UNITED STATES PATENT AND TRADEMARK OFFICE

APPLICATION NO.	FILING DATE	FIRST NAMED INVENTOR	ATTORNEY DOCKET NO.	CONFIRMATION NO.
10/016,051	12/06/2001	Yoshitaka Mishima	SHC0162	6019

Office Action Summary

DETAILED ACTION

FIG.2

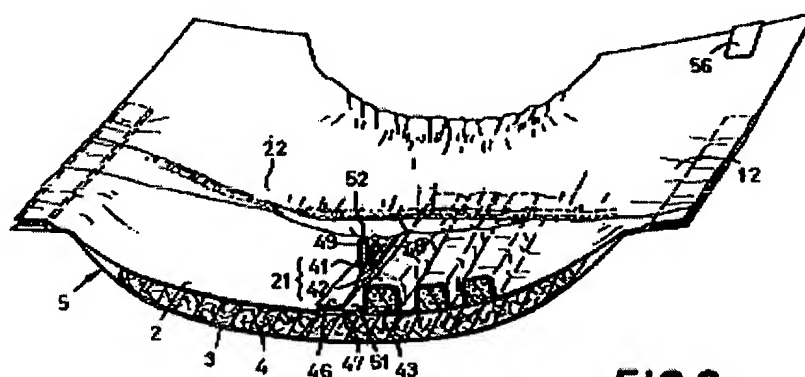
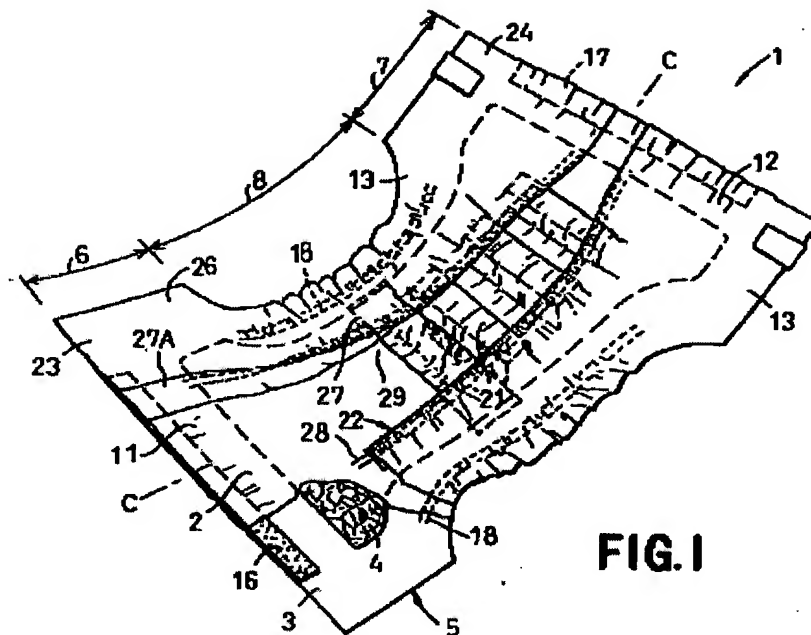
Regarding claim 1, Mishima *et al.* teach a disposable undergarment (1) comprising:

a skin-contactable surface (2);

a non skin-contactable surface (3) opposed to the skin-contactable surface (2);

a liquid pervious base sheet (3) contoured by longitudinally opposite end portions (11, 12) extending in a transverse direction and transversely opposite side edge portions (13) extending in a longitudinal direction (C-C);

a liquid-absorbent panel (4) attached to said base sheet (3) and lying on said **non** skin-contactable surface (3); and

skin contacting sheets (22) attached under extension in said longitudinal direction (C-C) to said skin-contactable surface (2) of said undergarment (1) so as to cover said liquid-absorbent panel (4), said skin-contactable sheets (22) being stretchable in said longitudinal direction (C-C) and substantially liquid-impervious, said skin-contactable sheets (22) having fixed surface areas (23, 24) secured to said longitudinally opposite end portions (11, 12) and free surface areas extending between said fixed surface areas (23, 24), which free surface areas are not fixed to said undergarment (1) so as to be spaced upward from said liquid-absorbent panel (4) as said

undergarment curves in said longitudinal direction (C-C) with its skin-contactable surface (2) inside,

said skin-contactable surface (2) of said undergarment (1) being provided with regions (27) in which said skin-contactable sheets (22) are absent so that said skin-contactable surface (2) inclusive of said liquid-absorbent panel (4) is partially exposed in said regions (27) in which said skin-contactable panels (22) are absent (see Fig. 2, below).
